Heritage Advisory Committee
January 22, 2014

SUBJECT: Case 19028: Non-Substantive Amendments to an Existing
Development Agreement and Substantial Alteration to Keith Hall,
1475 Hollis Street, Halifax

Rear Elevation - Keith Hall/Halkirk

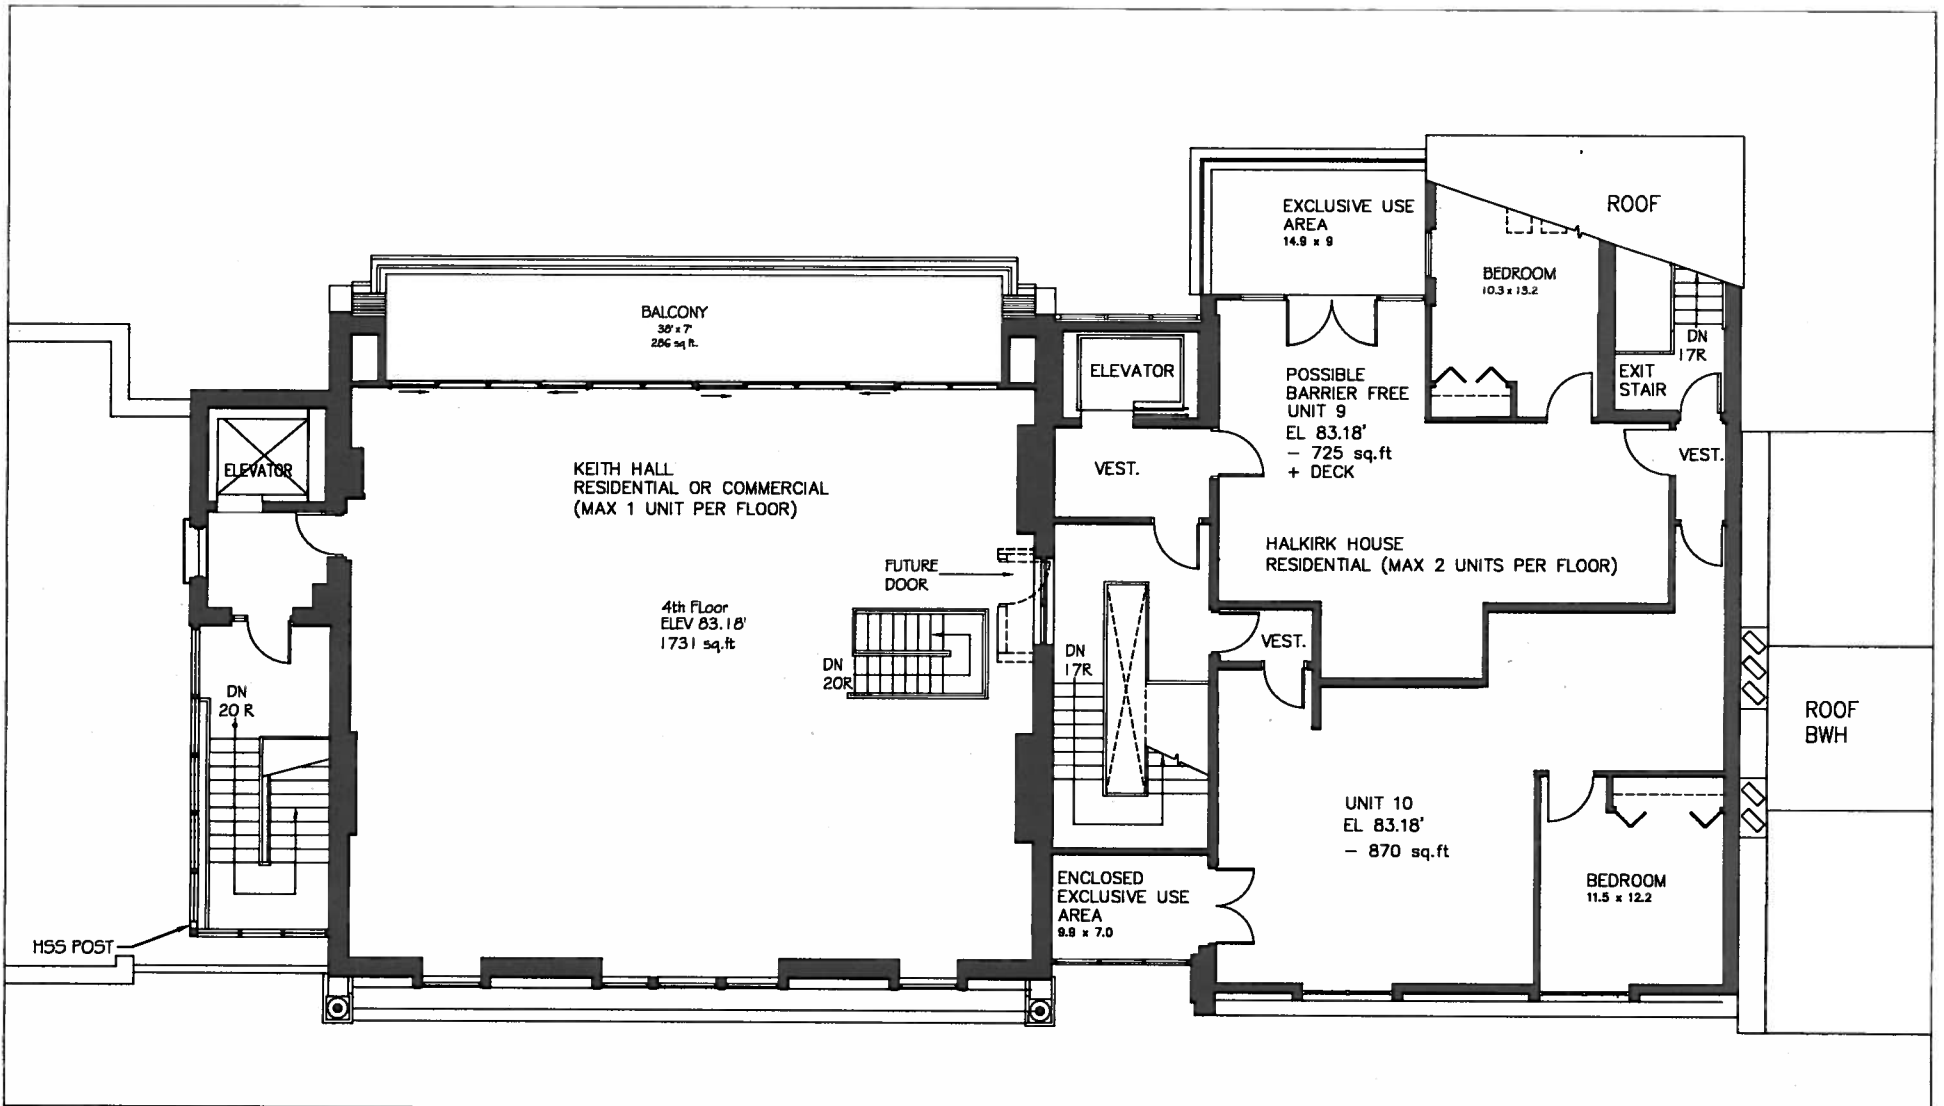
- *Historic Development:* The changes outlined in this report will not affect the heritage value of Keith Hall. The reinstatement of the mansard was designed based on historic photographic evidence. The rear of the roof will now have a slightly more modern appearance allowing it to better read as new work. The recession of the balcony into the roof will make the balcony less visible from the street, especially considering the grade change and the proposed abutting new building, the Alexander.

- *Preserve Distinctive Features:* The other notable modification to previously approved rear façade is the removal of balconies. The creation of these balconies would have required the removal of historic windows, including two stained glass windows. It was determined that the balconies are not required, and therefore the windows remain intact. There will be no historic materials removed with this proposed development.

(a)	that any municipally registered heritage property covered by the agreement is not altered to diminish its heritage value;	The proposed inset balcony will be at the rear of the historic building and much of the new mansard style roof will surround the balcony to limit its scale in relationship to the historic building.

(b)	that the development maintains the integrity of any municipally registered heritage property, streetscape or heritage conservation district of which it is part;	Although compatible with the historic building, the new mansard style roof will not be original to the building and the new inset balcony will serve to distinguish the new roof from the historic building.
